Commercial Plans RECEIVED 3/17/2025 DEPARTMENT OF ENGINEERING ENGINEERING REVIEW COPY

**NEW OFFICE / STORAGE**

38229 MANZELLA DRIVE, SLIDELL, LOUISIANA

**SITE PLAN- NEW WORK**

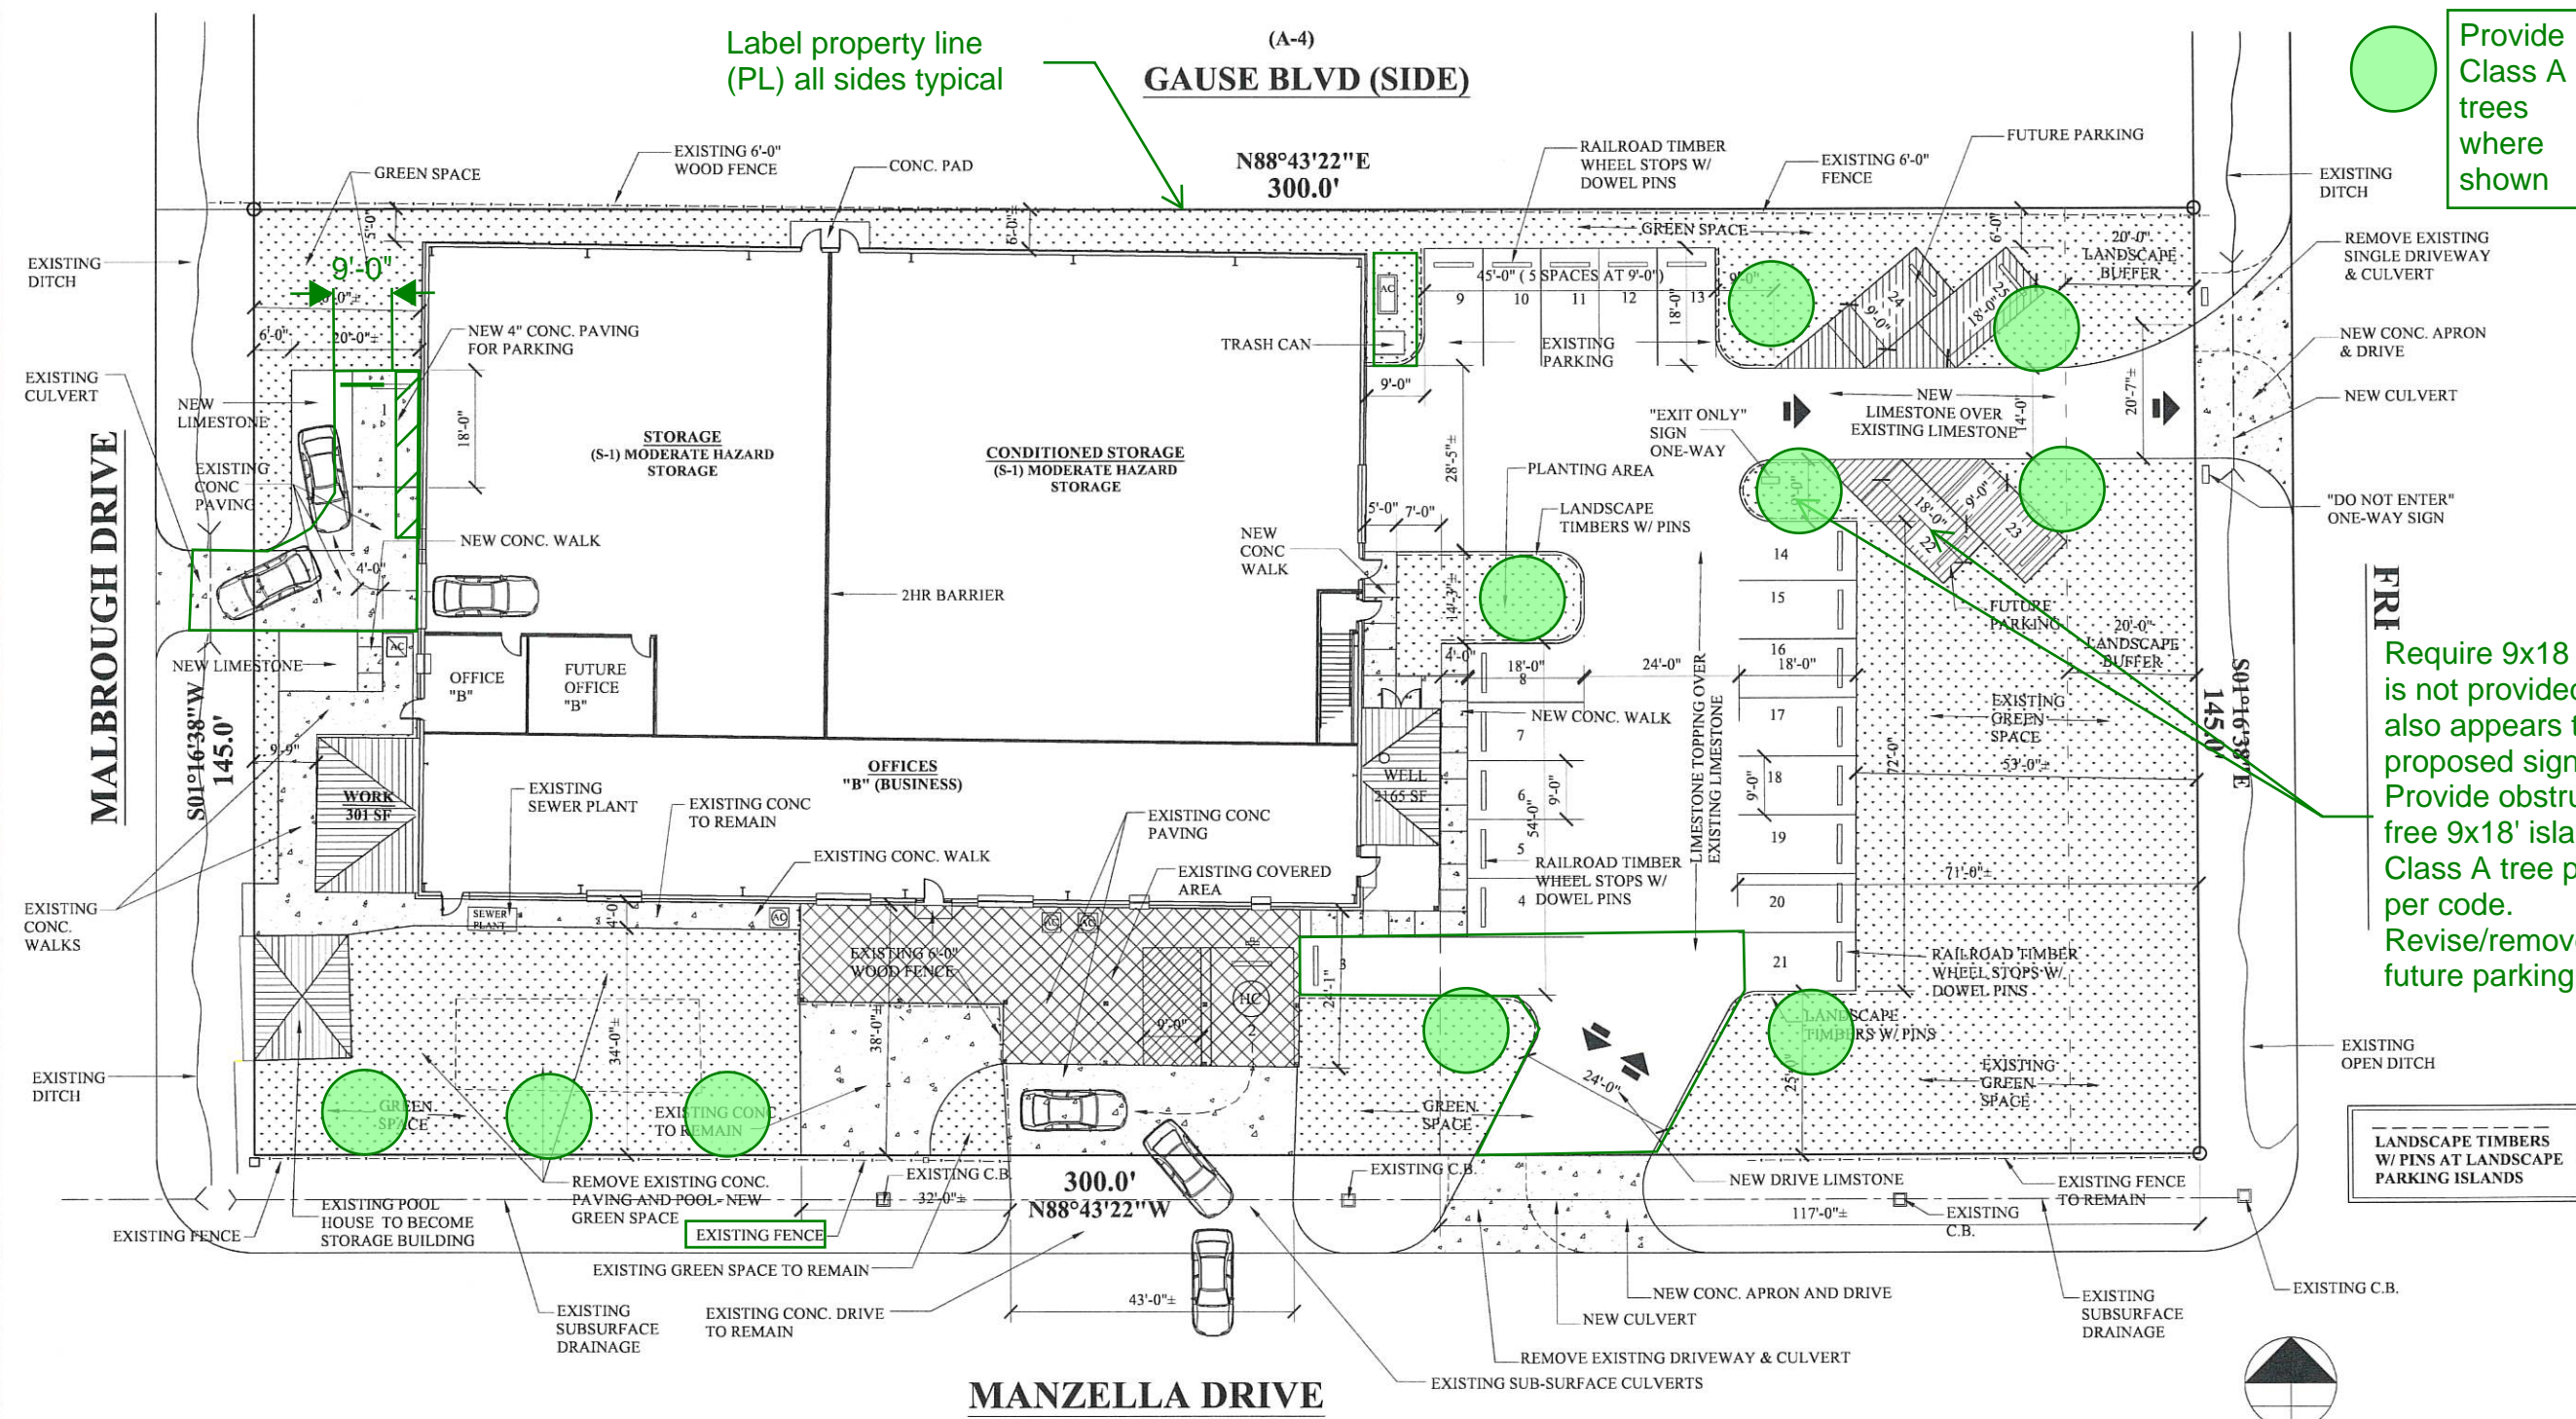
Provide 4' pedestrian access/safety space adjacent to bldg per code. Approved for only (1) 9x18' parking space. Suggest widening radius as discussed, not increasing paving further into street buffer.

Label property line (PL) all sides typical

Provide Class A trees where shown

Require 9x18 island is not provided aqdm also appears to have proposed signage. Provide obstruction free 9x18' island for Class A tree planting per code. Revise/remove this future parking space.

provide scaled drawing per code
